November 23, 2024

**RE: Review Comments for QuickChek, 2 Lakeside Road, Town of Newburgh, NY;
CM Project #123-001.15, Town Project #24-01; NYSDOT SEQR #23-215**

Photo 1- Truck attempting to park in west side of PILOT – took driver 10 minutes with the help of a spotter because the drive lanes on this side are too narrow.

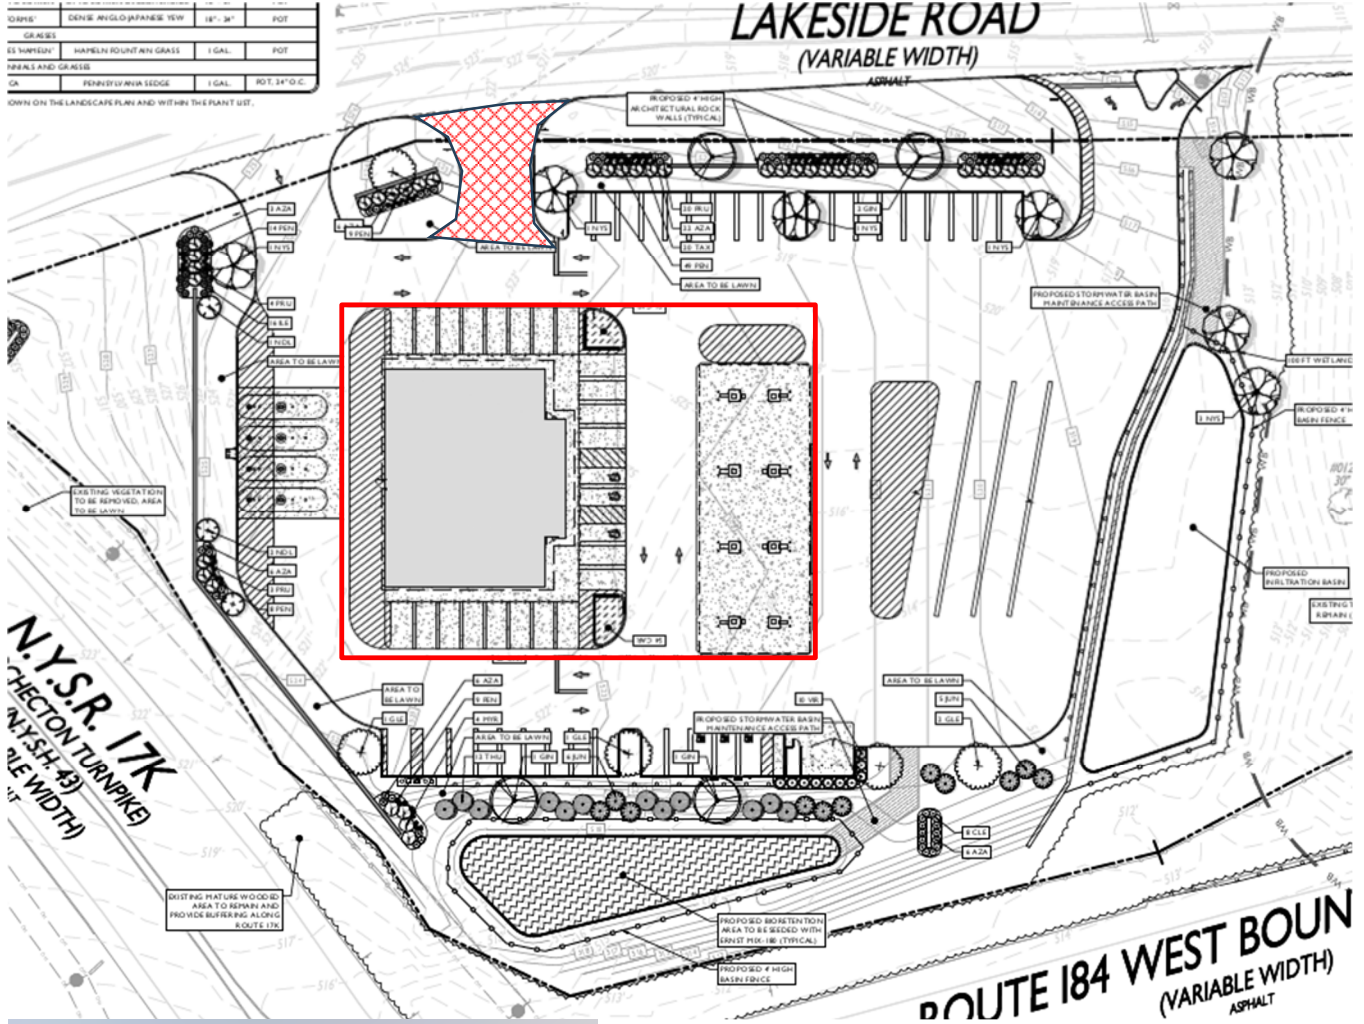
Photo 2- 17K WB left turning truck blocked from entering due to internal PILOT congestion. Camera looking EB on 17K.
